Access Compliance Report Public Rights-of-Way (Pedestrian Signals)

Main Street: **SENDERO_WAY** Cross Street: **ANTONIO_PKWY** Location: **NW**

ADA ID: **SGRK211116133710** Signal Type: **One Push Button-Non APS** Overall Compliance: **No** Severity Scores: **BTN 1: 35** **BTN 2: N/A** **No BTN: N/A**

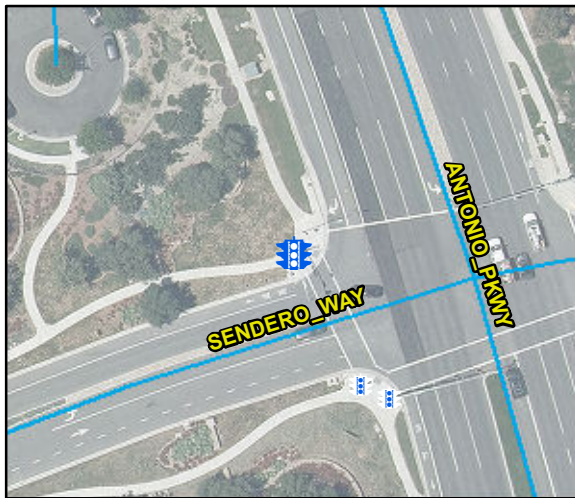
OC Std/PROW: MUTCD 4e.08, R404.2, R404.3

Possible Solutions: Replace Signal Push Button With APS Button. Remove & Relocate Sign.
